## 2-WIRE NO. 1 ELECTRONIC SWITCHING SYSTEM GENERAL DESCRIPTION

**1.001** This addendum supplements Section 966-100-100, Issue 6. Place this pink sheet ahead of Page 1 of this section.

**1.002** This addendum is issued to:

**Fig. 21 -- Remreed Line Link Network Frame Configurations**

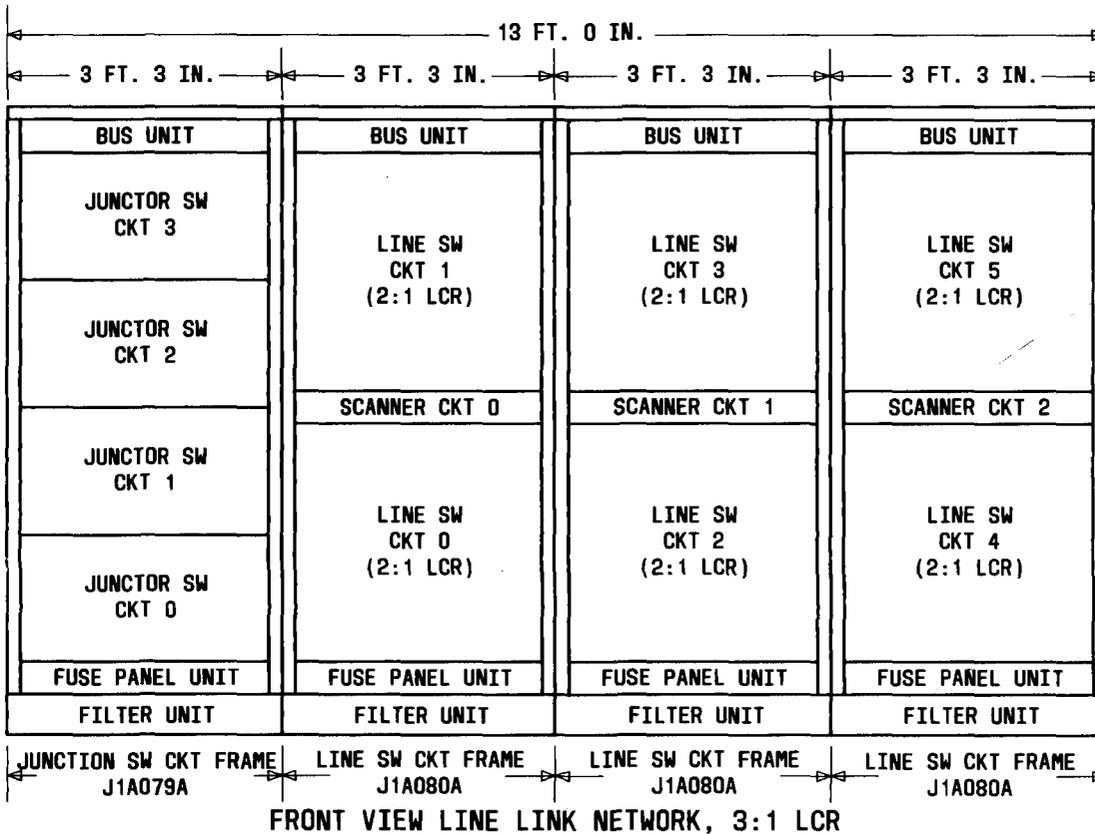
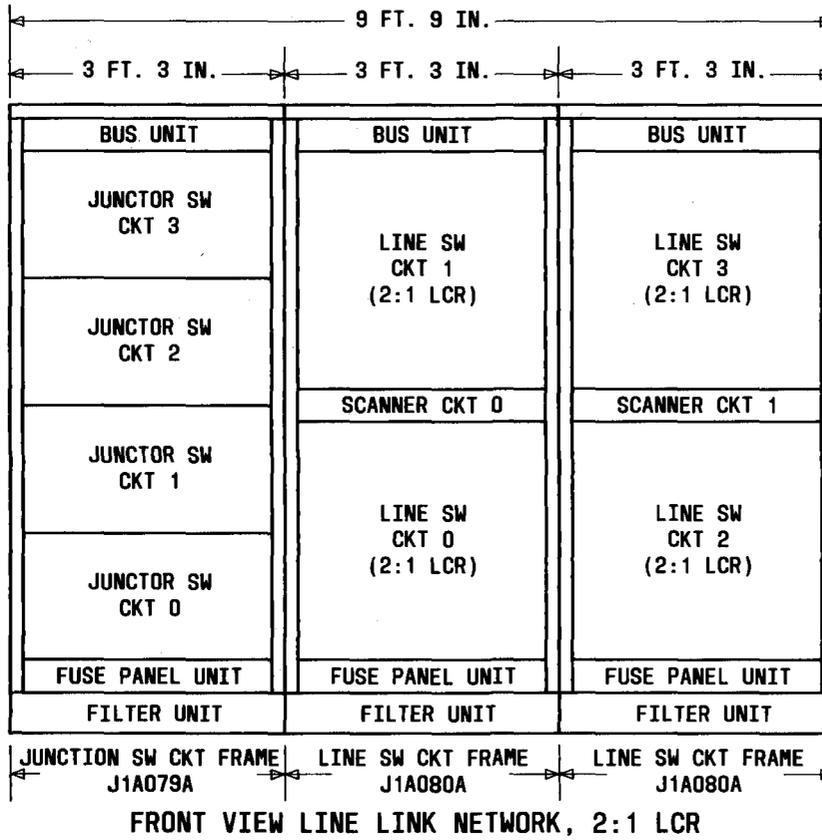
**2.002** On Page 31, in Fig. 21, the junctor switching circuit frame should be shown on the left of the configuration in both illustrations. The attached Fig. 21 shows the correct configuration.
